**APPLICATION REVIEW FOR
LOW IMPACT HYDROPOWER INSTITUTE RECERTIFICATION
of the
Methuen Falls Hydro Project
LIHI #111 FERC P-8093**

June 7, 2019

Application Reviewer: Diane Barr, Camas, LLC

This report provides review findings and recommendations related to the application submitted to the Low Impact Hydropower Institute (LIHI) on February 19, 2019 from Olson Electric Development Co., Inc. (Applicant) for Low Impact Hydropower Recertification of the Methuen Falls Hydroelectric Project (the Project).

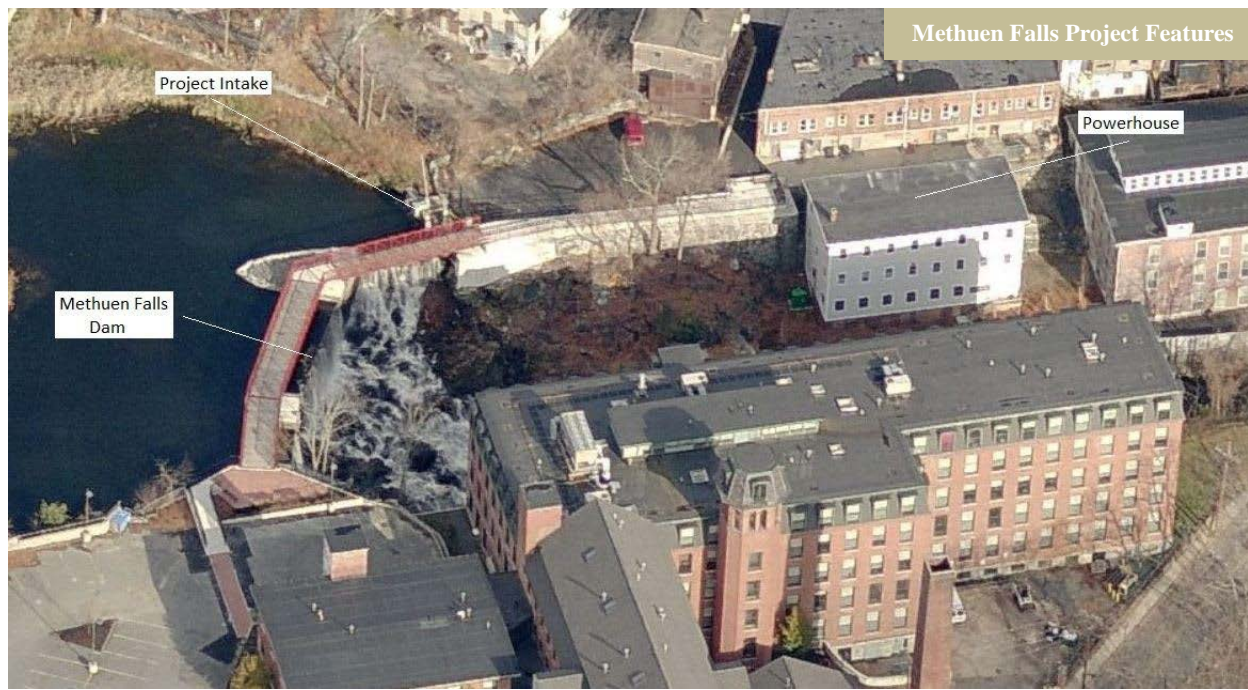
The applicant properly selected three zones of effect for the Facility (Figure 1). The applicant defined the following zones:

- Zone 1) Impoundment, 8.7-acre impoundment.
- Zone 2) Bypassed Reach, 150 feet long.
- Zone 3) Downstream: Project Tailrace to Harvey Falls Dam

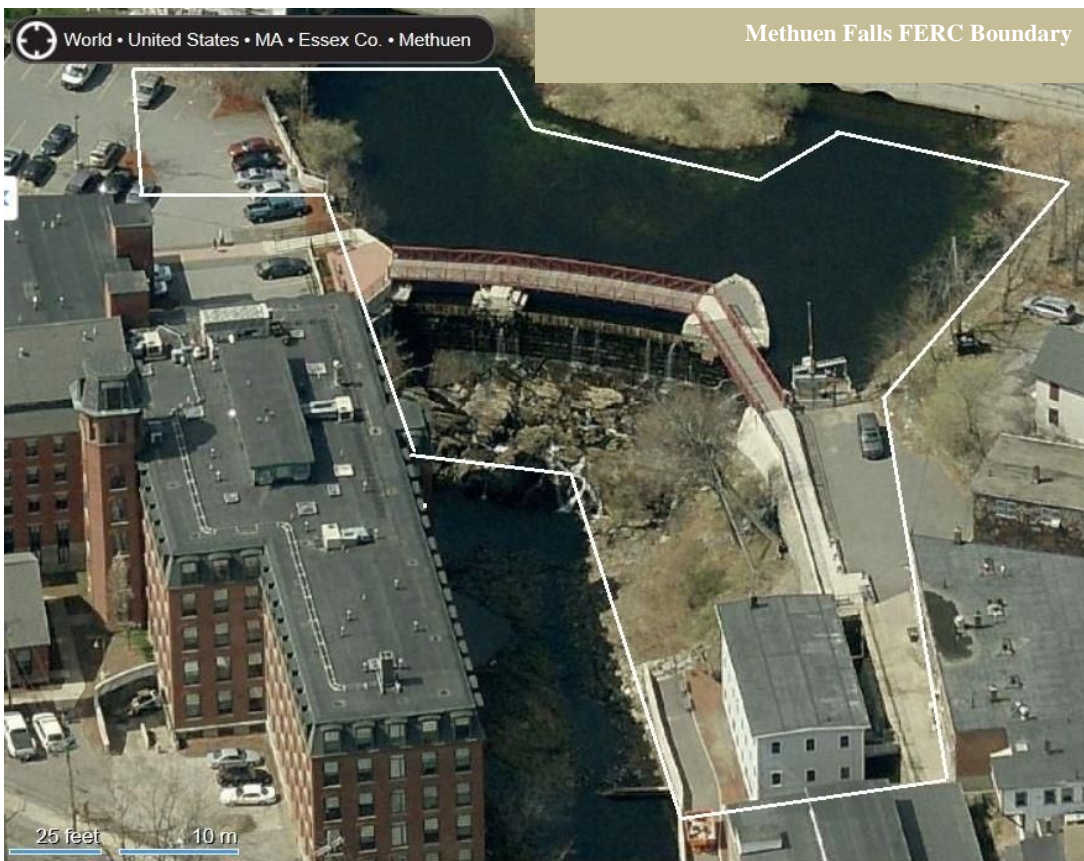
The Applicant selected Standard 1, Not Applicable/De Minimis for all ZOE's. There are no recreation facilities associated with the Project and only a footbridge over the dam provides public access (see figure below). The area is used by kayakers, with their put-in located outside the FERC boundary. Therefore, the Project satisfies this LIHI criterion.
